Manual Change Information

SUBJECT : Misprint in schematic diagram

Model & Manual No.	Location	Reference Information	Affected serial No.
RX-1001VBK No.20057	Schematic Diagram (ENH-100-1)	EA-00-5036	#1~

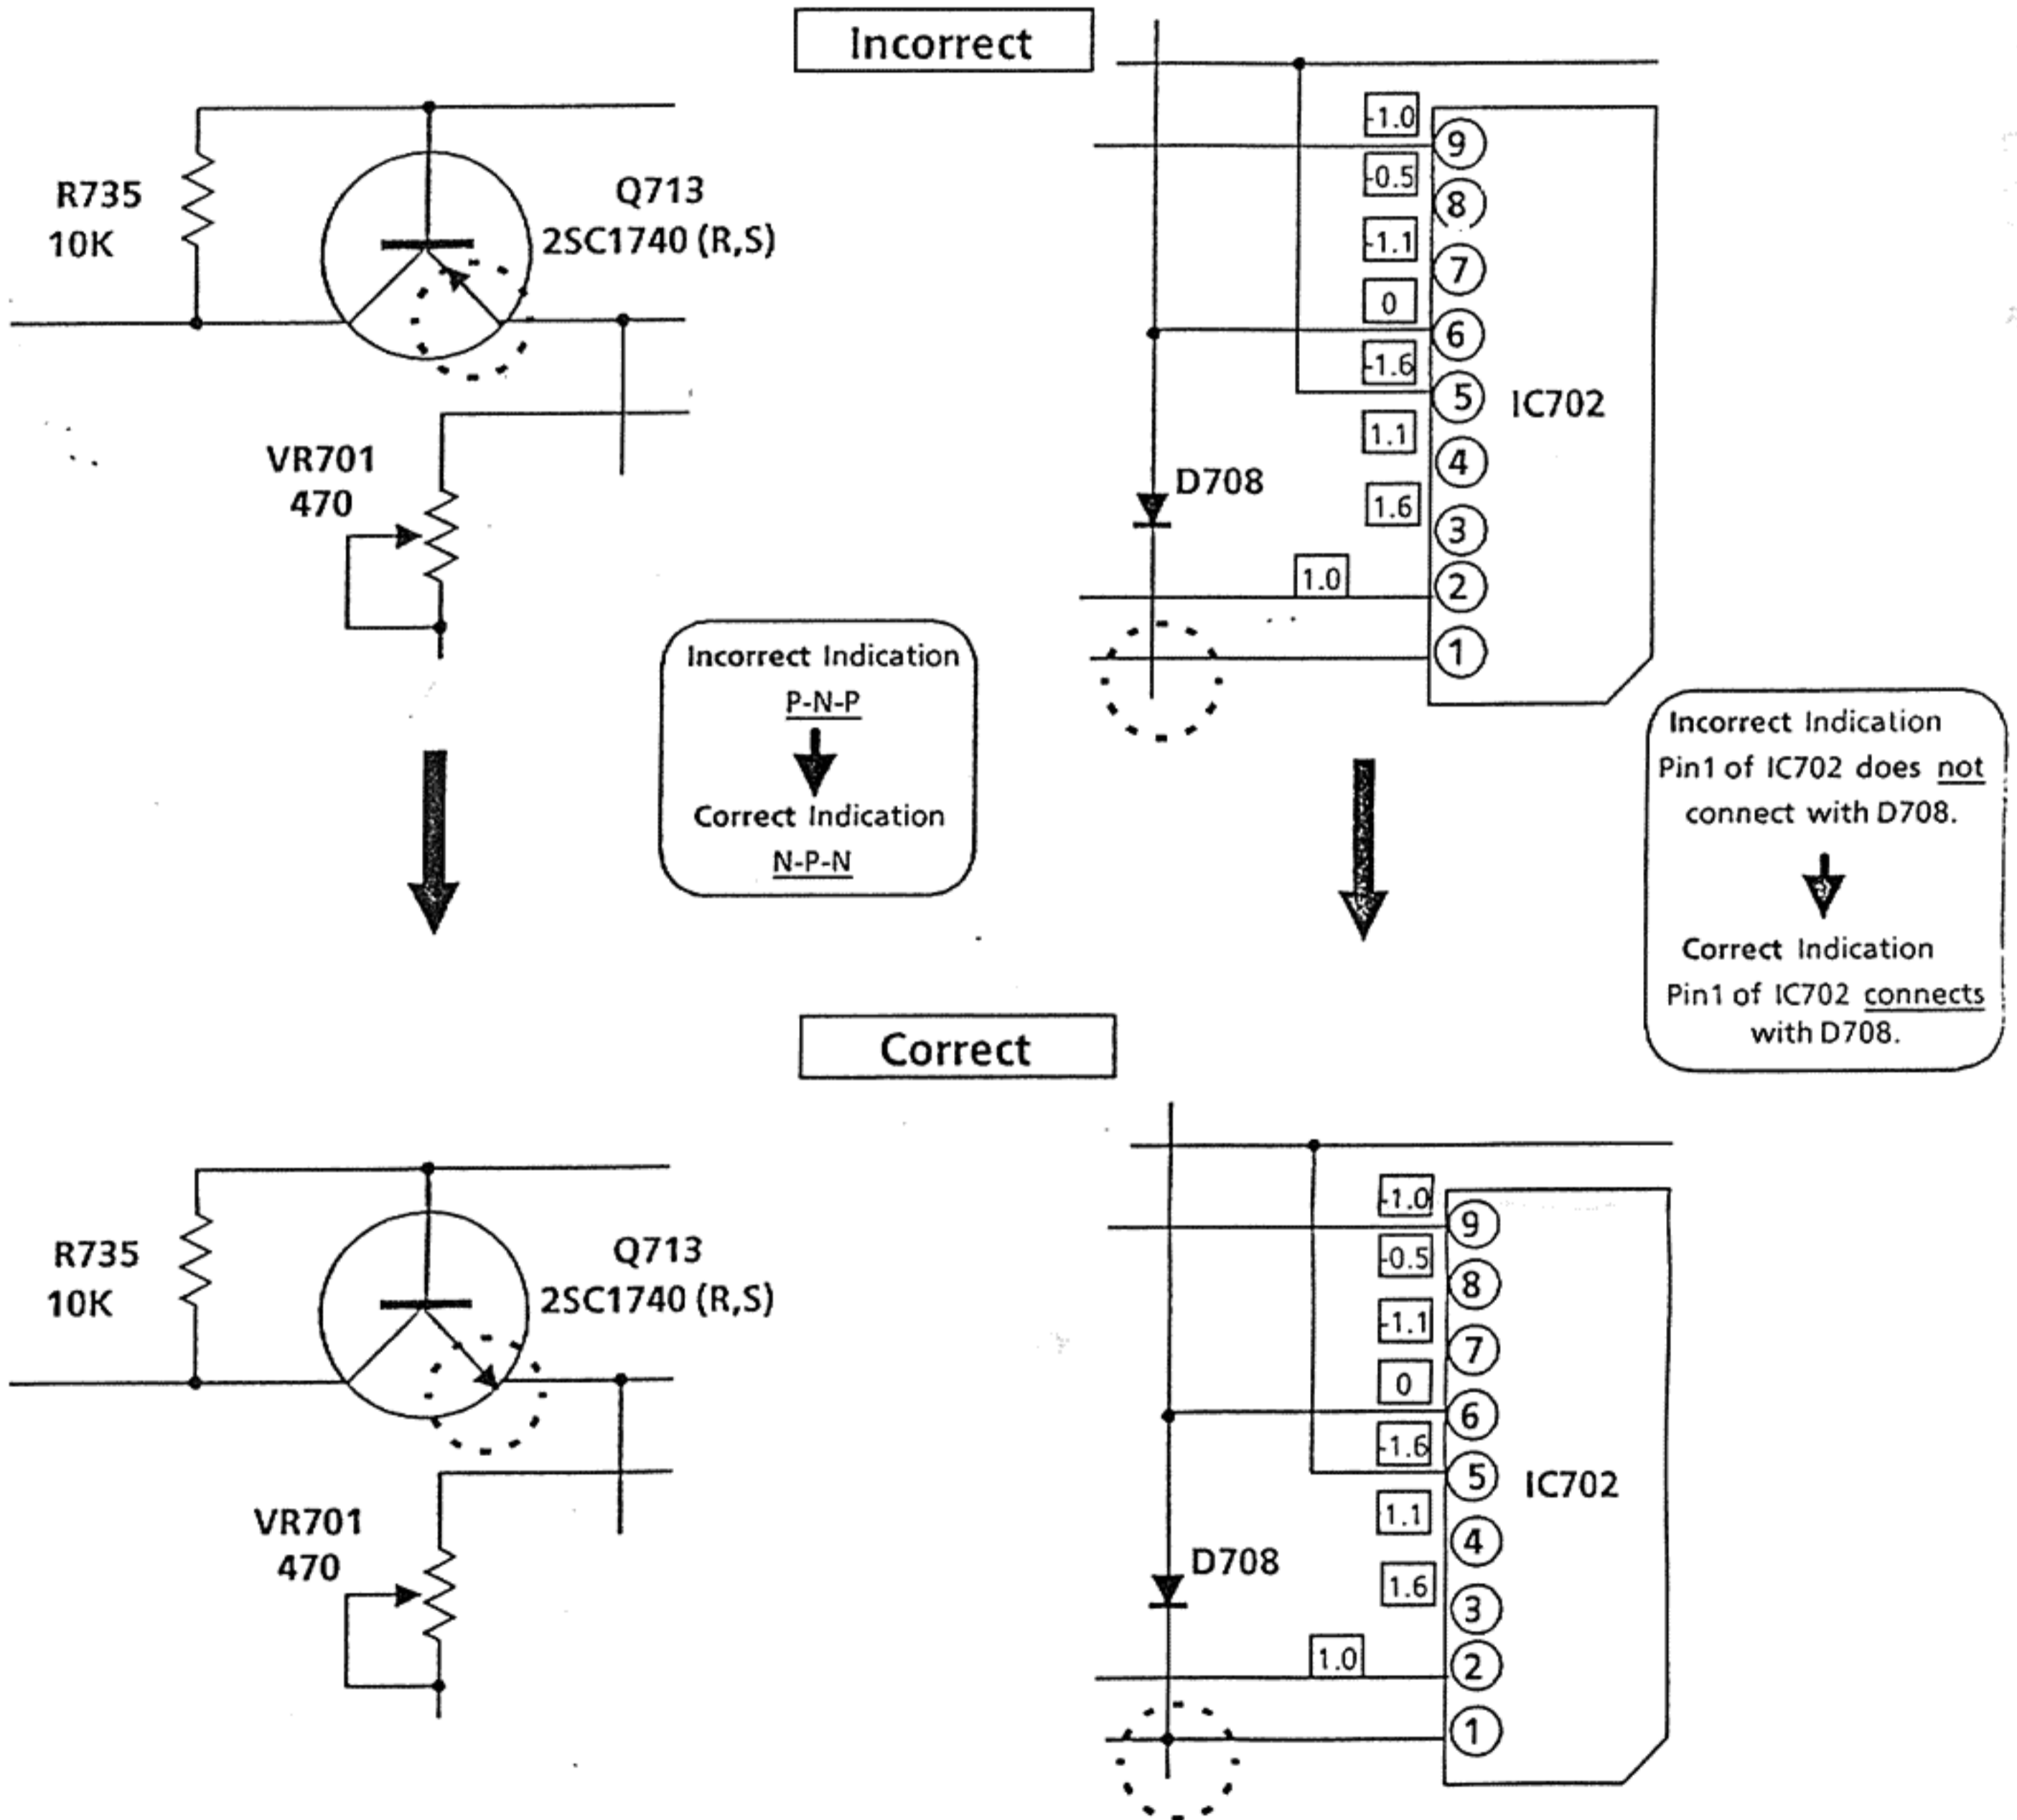
■ The following items have been changed. Please note these in your service manual.
